**REPORT OF THE INDEPENDENT HEARING
AND ASSESSMENT PANEL**

MOOLARBEN COAL PROJECT

Prepared for:

February 2007

Figure 5.1: Predicted versus measured vertical displacement over longwall panels at Ulan Colliery for L95%CL, Mean and U95%CL.

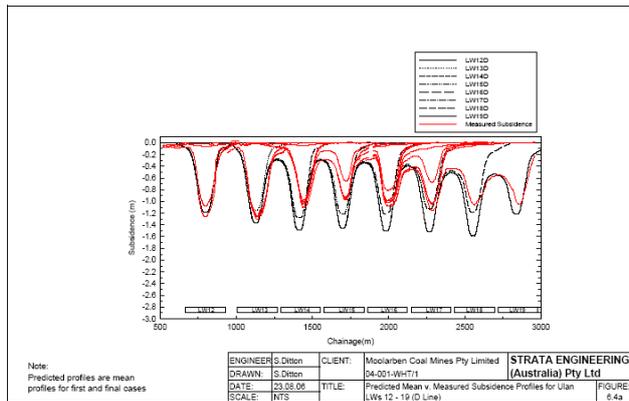
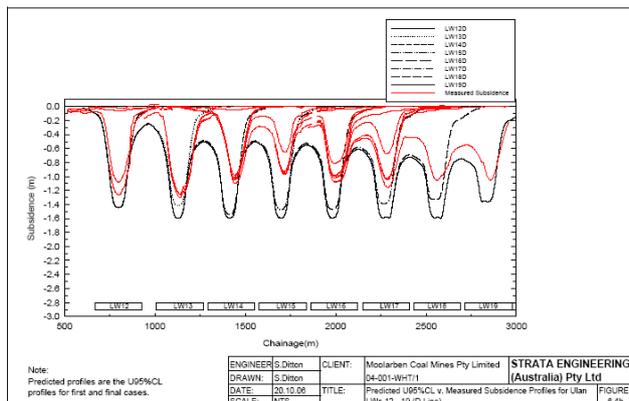
The IHAP has concluded that this uncertainty is adequately accounted for by SEPL basing subsidence predictions on the U95%CL. Furthermore, the IHAP recognises that the initial longwall panels in the MCP provide the opportunity to validate the prediction methodology and to calibrate it to MCP site specific conditions without unduly jeopardising the integrity of significant surface features.

When applied to Ulan Colliery data, the U95%CL approach has resulted in maximum vertical displacement having been over predicted by between 11 and 20% over one longwall panel, between 35 and 50% over two longwall panels and by between 50 and 70% over the remaining five panels, as illustrated on Figure 5.1(c). Predicted tilts have exceeded measured tilts over all panels. Predicted magnitudes of strain are not inconsistent with measured magnitudes but there is a lower level of correlation in regards to strain distribution (location).

reasonableness and accuracy of this approach can only be confirmed in the light of local mining experience.

Figure 5.2: Base data used in SEPL fracture height model.

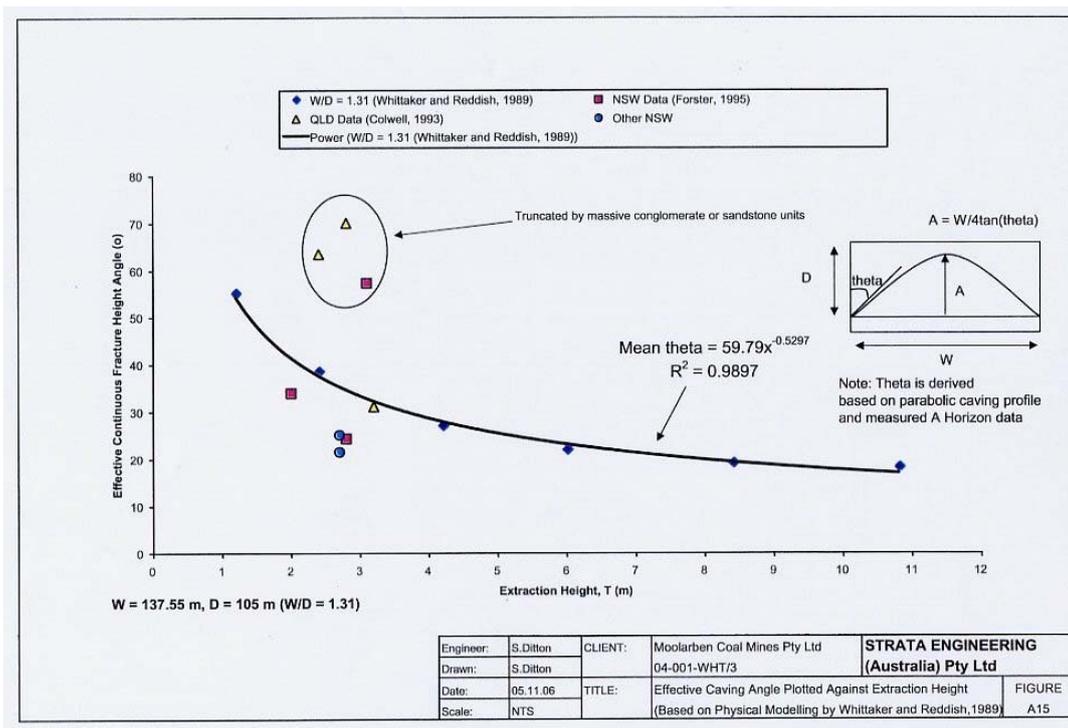
- Drilling fluid loss is not necessarily a reliable measure of fracturing and change in permeability.
- The revised model is premised on a number of untested, albeit reasonable, assumptions.

- The fracture heights predicted with the revised model are still less than those predicted by a number of other fracture models that have found successful application in the field and by some numerical models which also find successful application in the field. (Of course, these successful models might still be over-predicting the height of fracturing.)

The predicted fracture heights may well prove to be correct. However, the IHAP is of the opinion that the prediction model is not sufficiently robust for the IHAP to be confident in the outcomes at this point in time. The IHAP notes that SEPL have made various references to the model being preliminary, that the problem is of a complex

Figure 6.1: Piezometric surface for model MC1.4 layer 4 - Ulan seam at 2021 (after Aquaterra Figure 4.10 in PPR). Yellow shading shows approximate area of depressurisation within the coal seam induced by panel extractions.

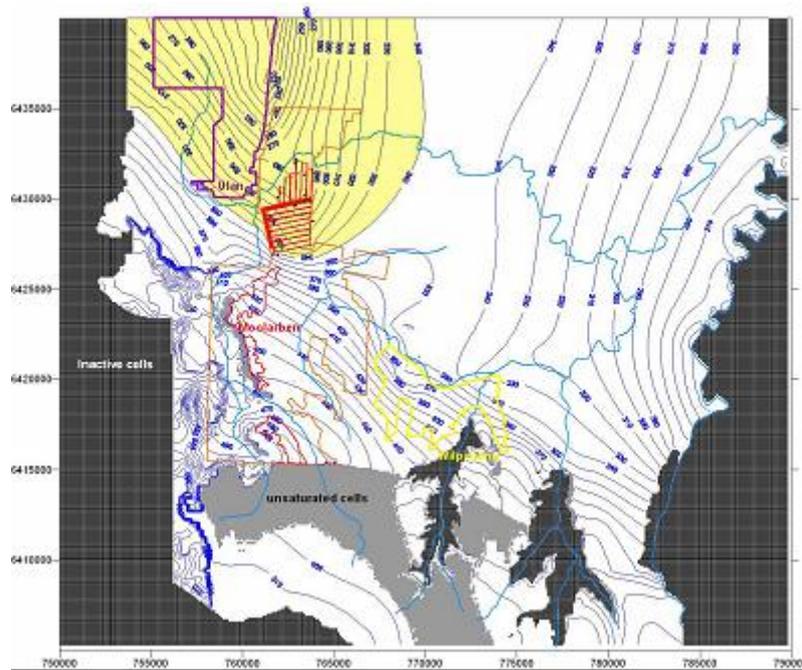
In view of the concerns raised by the IHAP in relation to prior modelling, a more detailed examination of the preferred model has been conducted. Such examination has identified ongoing concerns that include restrictive representation of the underground failure regimes at both UCML and MCMPL, leading to unrealistically low depressurisation of strata and associated under-estimation of seepage rates to mining operations. Figures 6.1 and 6.2 illustrate this. Figure 6.1²⁸ provides a model simulation of the groundwater head distribution or piezometric surface, within the Ulan seam (model layer 4) at the completion of proposed mining at MCMPL in 2021. Clearly there is a distinct piezometric low regime (shaded yellow) prevailing over both UCML and MCMPL extracted panels and surrounding areas. In contrast, Figure 6.2 provides groundwater heads within the overlying Permian strata at a datum horizon just 25m above the coal seam (model node horizon). These heads exhibit little evidence of seam depressurisation. The IHAP has difficulty in accepting this lack of pressure loss as a realistic prediction of the impacts of longwall mining.

Model extents also appear to be insufficient to accommodate regional depressurisations arising from simulated mining, in a natural way. This is suggested by the geometry of the piezometric contours exhibited in Figure 6.1 in the north-western part of the model (shaded yellow). Here the distinct north-south trend of the contours suggests that pressure losses may be influenced and enhanced substantially by the northern and western boundaries of the model. The IHAP has difficulty in reconciling the impacts of mining with the impacts of boundary proximity.
